Access Compliance Report

Public Rights-of-Way

Intersection ID: 15242	Main Street: E_INDEPENDENCE_BV	Cross Street: N_WENDOVER_RD_RA	Location: SE
ADA ID: 5A643CC2BC90	Ramp Type: Perp	Initial Pass/Fail: Fail	Overall Compliance: No
			Severity Score: 21.25

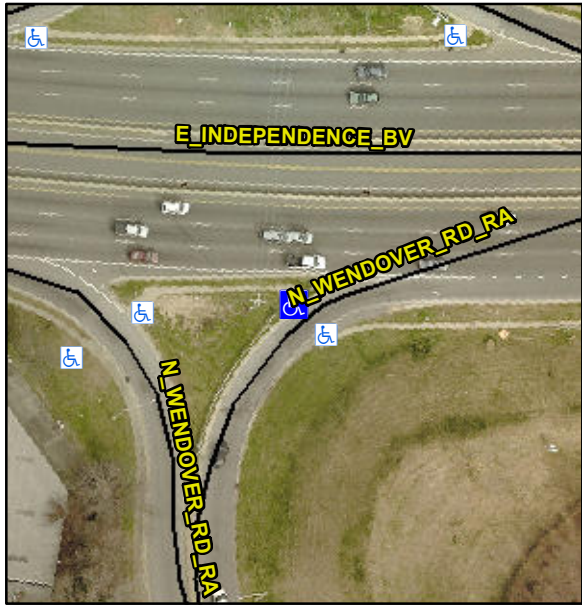
Codes/Mitigation Info/Possible Solution		Field Measurements/Component Compliance						
	Possible Solutions:		Compliance	Description	Data	Compliance	Description	Data
	Remove & Replace Entire Ramp.		N/A	Ramp Length (in)	62.0	No	Ramp Slope (%)	9.0
			No	Ramp Width (in)	41.0	Yes	Ramp XSlope (%)	0.1
			N/A	Flare Type LT	N/A	N/A	Flare Type RT	N/A
			N/A	Flare Slope LT (%)	N/A	N/A	Flare Slope RT (%)	N/A
			N/A	Flare Traversable LT?	N/A	N/A	Flare Traversable RT?	N/A
			N/A	Landing Length (in)	N/A	N/A	DWS Provided?	N/A
			N/A	Landing Width (in)	N/A	N/A	DWS Contrast?	N/A
			N/A	Landing Slope (%)	N/A	N/A	DWS Length (in)	N/A
			N/A	Landing X Slope (%)	N/A	N/A	DWS Full Width?	N/A
Surveyor Notes:		N/A	N/A	Landing Curb? (Y/N)	N/A	N/A	DWS Offset (in)	N/A
PROW/ADA:		Not Found, R304.5.1, R304.2.2		N/A	Shared Landing?	N/A		
			N/A	Gutter Ponding?	N/A	N/A	Gutter Slope (%)	N/A
			N/A	Gutter Lip Ht (in)	N/A	N/A	Gutter X Slope (%)	N/A

N/A	Painted X Walk1?	No	N/A	Painted X Walk2?	N/A
				X Walk 1 Direction	To S		X Walk 2 Direction	N/A
			N/A	X Walk 1 Width (in)	N/A	N/A	X Walk 2 Width (in)	N/A
				X Walk 1 Slope (%)	7.8		X Walk 2 Slope (%)	N/A
				X Walk 1 X Slope (%)	0.9		X Walk 2 X Slope (%)	N/A
			N/A	Ramp inside XWalk1?	N/A	N/A	Ramp inside XWalk2?	N/A
				Road Slope (%)	N/A	N/A	Clear Space?	N/A
				Road X Slope (%)	N/A	N/A	Clear Space to XWalk (in)	N/A
			N/A	Any Obstructions?	N/A	N/A	Storm Grate/Utility Hazard?	N/A
				Obstruction Type			Storm Grate/Utility Type	
						N/A		N/A
						Yes	Surface Condition? (G/P)	Good
